Subject: Final Environmental Assessment and Finding of No Significant Impact (FEA-FONSI) for Highway Improvements, Roadway Repair, Vicinity of 3798 Tantalus Drive, Honolulu, Hawaii

Name of Project: Highway Improvements, Roadway Repair, Vicinity of 3798 Tantalus Drive
Applicable Law: Ch, 343, HRS
Type of Document: FEA/FONSI
Island: O'ahu
District: Honolulu (Kona)
TMK: 2-5-012: 004 and 014; 2-5-019: 005 and 009
Permits Required: DOH Noise Permit , Noise Variance, DOFAW Special Use Permit

TRAFFIC CONTROL PLAN (24-HOUR ROAD CLOSURE)

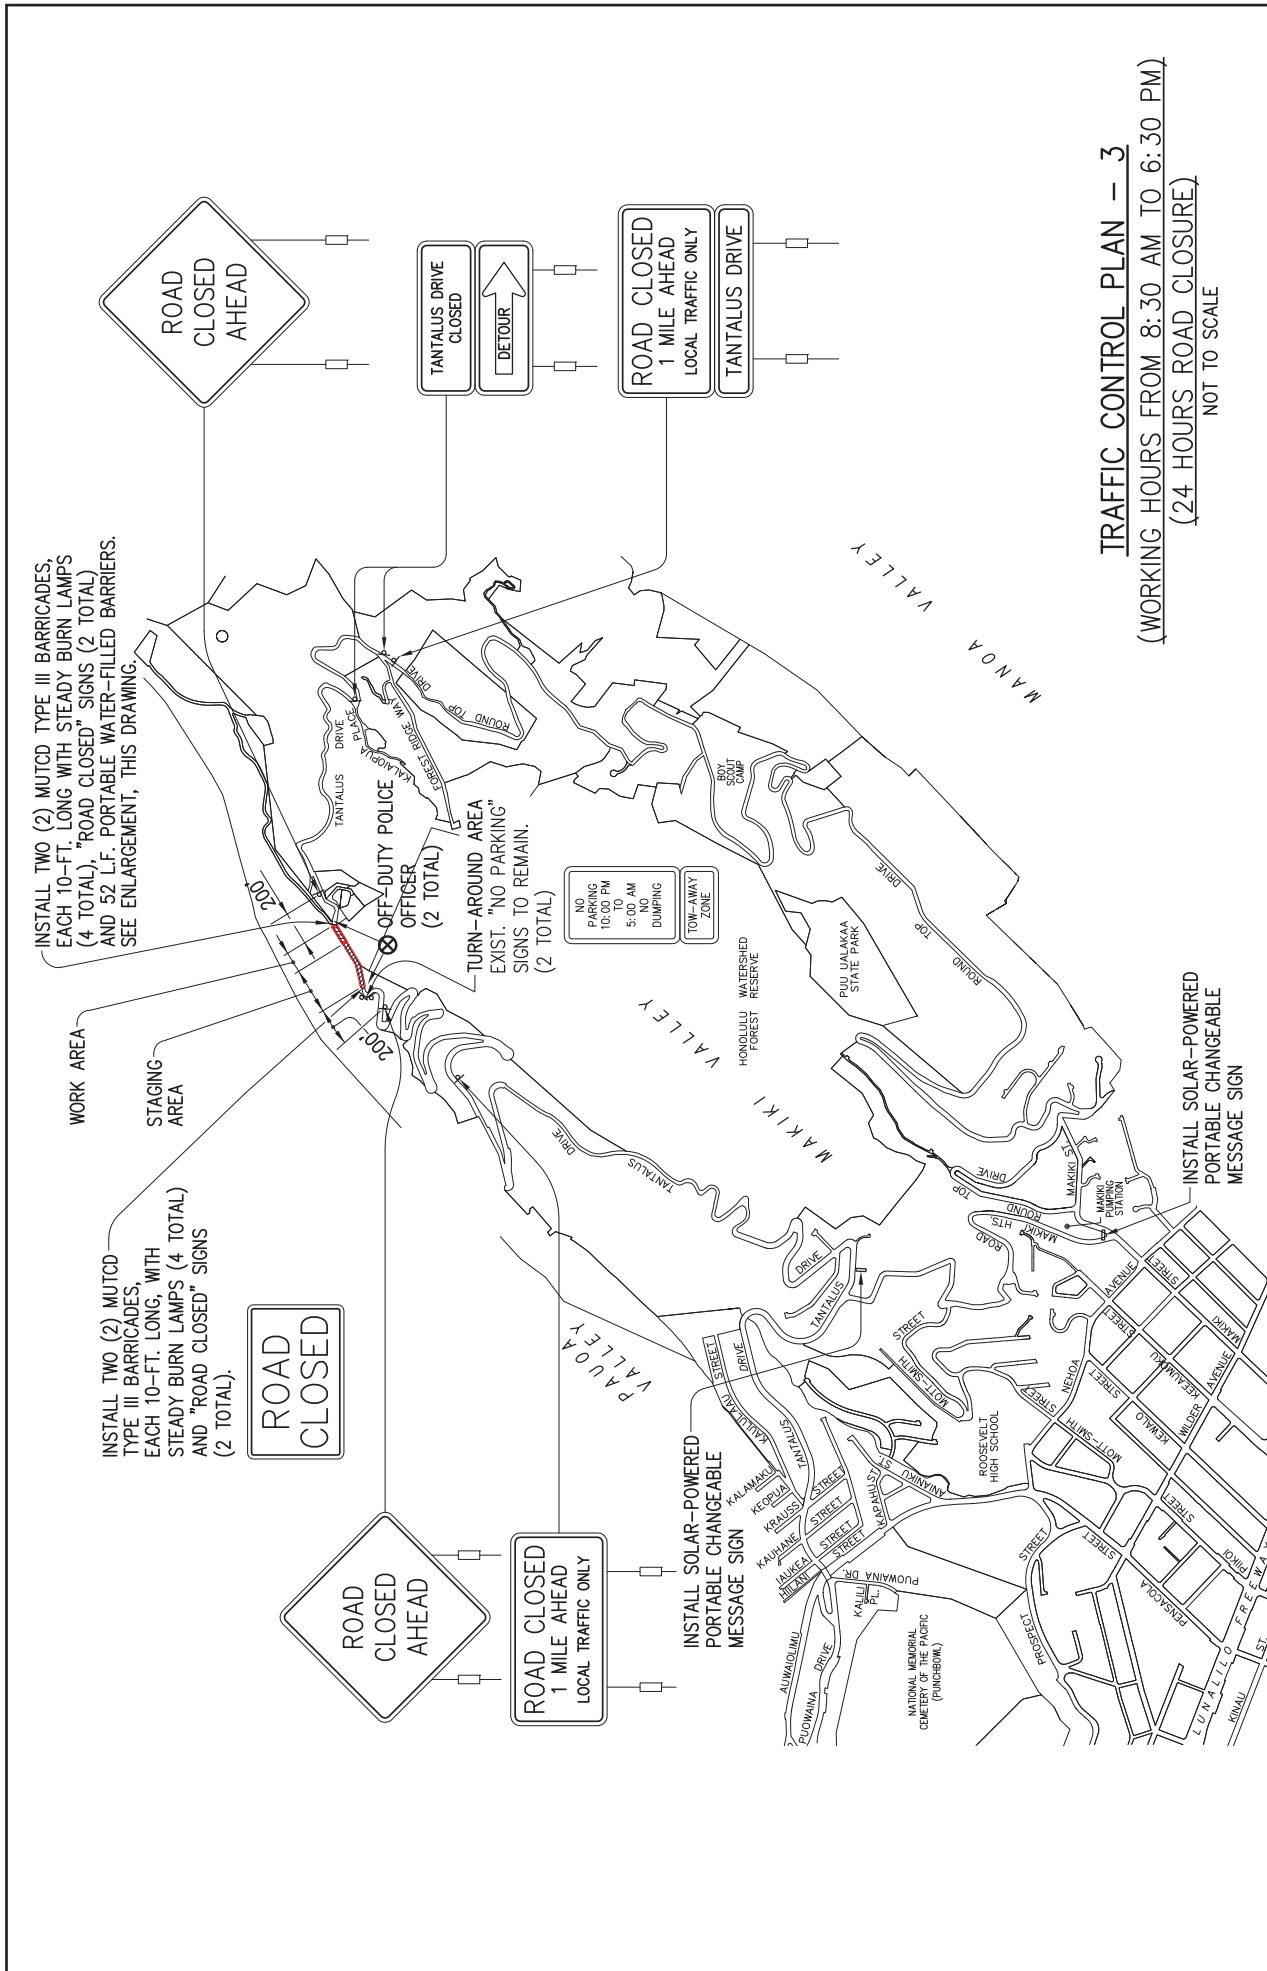
2. Figure 7 on page 2-12 does not show sign at bottom of Round Top indicating road closure. Without notice, tourist vehicles will need to turn around and drive back down Round Top.

Response: A comprehensive set of traffic control plans (TCPs) will be prepared and submitted to the Department of Transportation Services and Department of Planning and Permitting for review and approval. TCP signage, public notices, and the 24-hour hotline will combine to give motorists and other road users current information about changes in traffic patterns. The TCPs will include strategic placement of road closure signs. Figure 7—Figure 11 in the Final Environmental Assessment (FEA)—shows the updated sign locations.

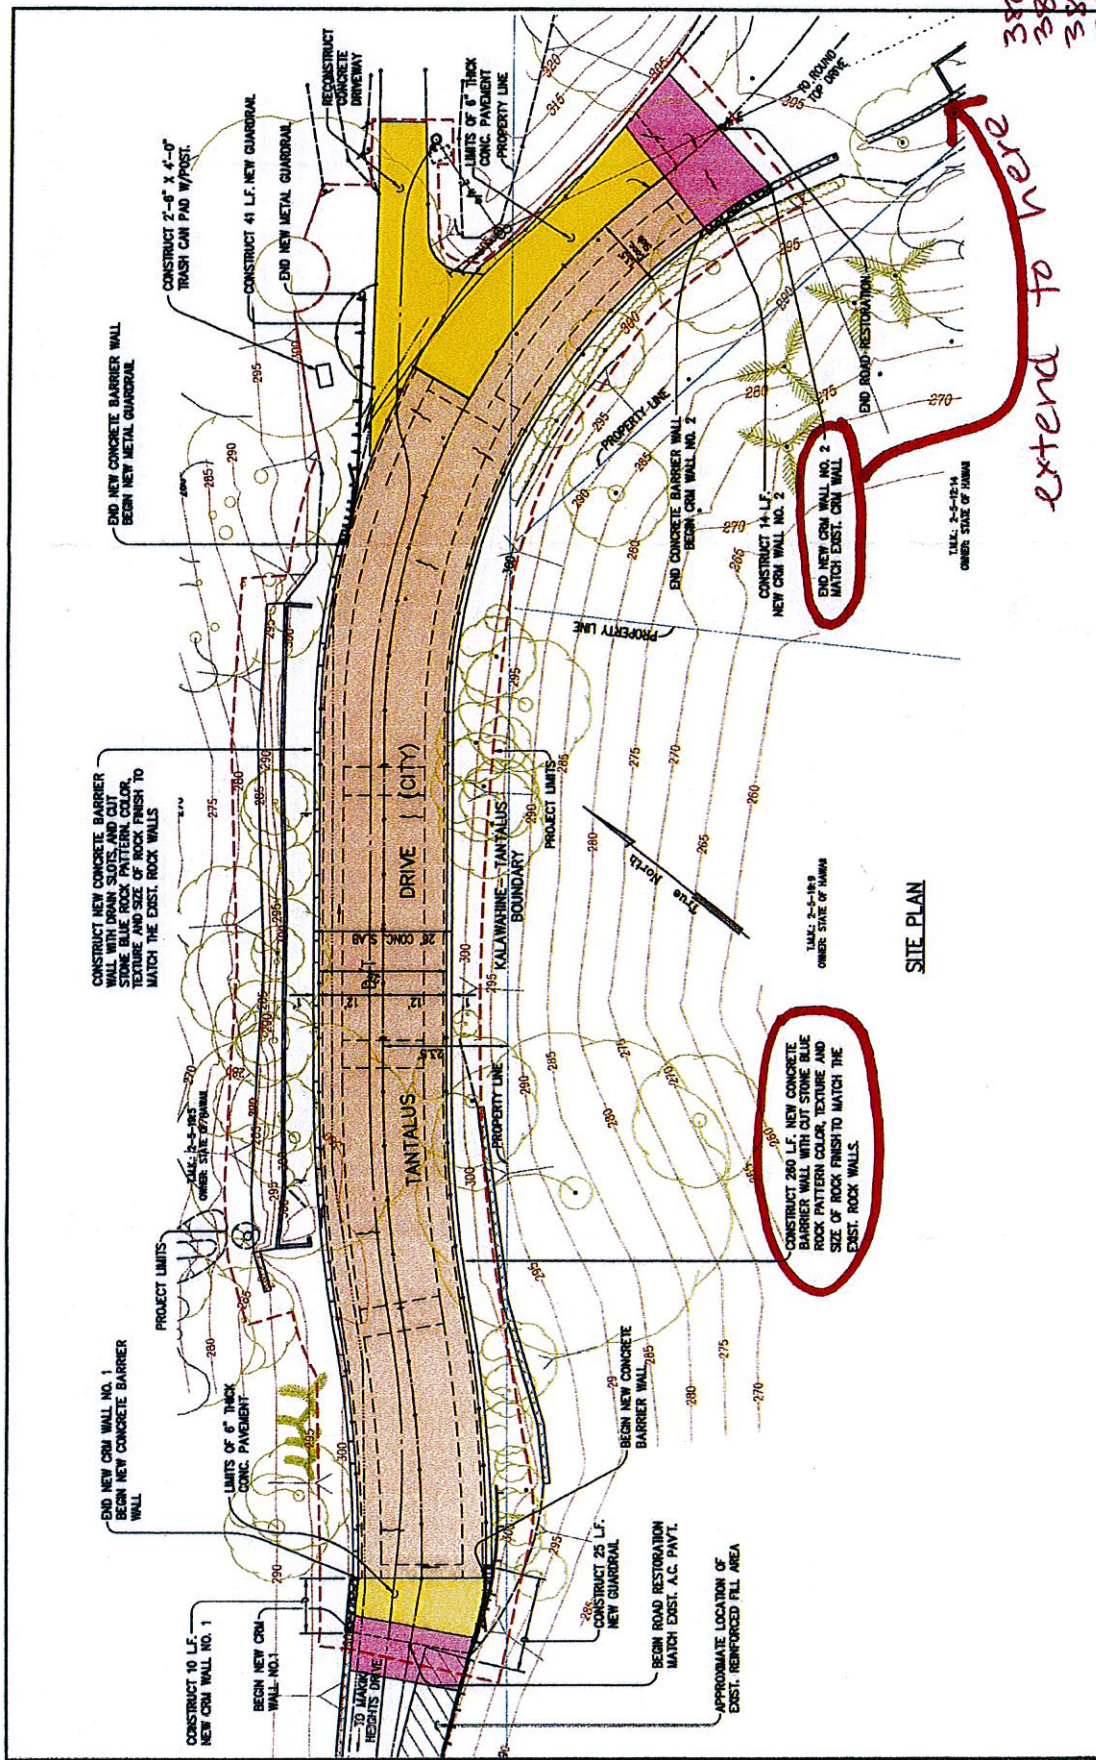
We would like the "14 L.F. new CRM Wall No. 2" to be extended to the end by the parking area because the existing wall is deteriorated and there is a gap or missing section. The deterioration and gap allow water to overflow onto our lower properties. Please see our notes on attached "Site Plan."

We would also ask that a berm be installed along the Makiki side edge of Tantalus Drive starting up the hill east for about 50' past 3825 Tantalus Drive's 2 mailboxes and to connect or end up at the start of the concrete blocks near the top of our private driveway. This would help stop the excessive water drainage onto our properties. We grew up there in the 1950's and there never used to be this runoff problem. We believe the grading of the road has changed with re asphaltting resulting in this very damaging water flow. A berm would be a much cheaper solution than re grading that part of Tantalus Drive.
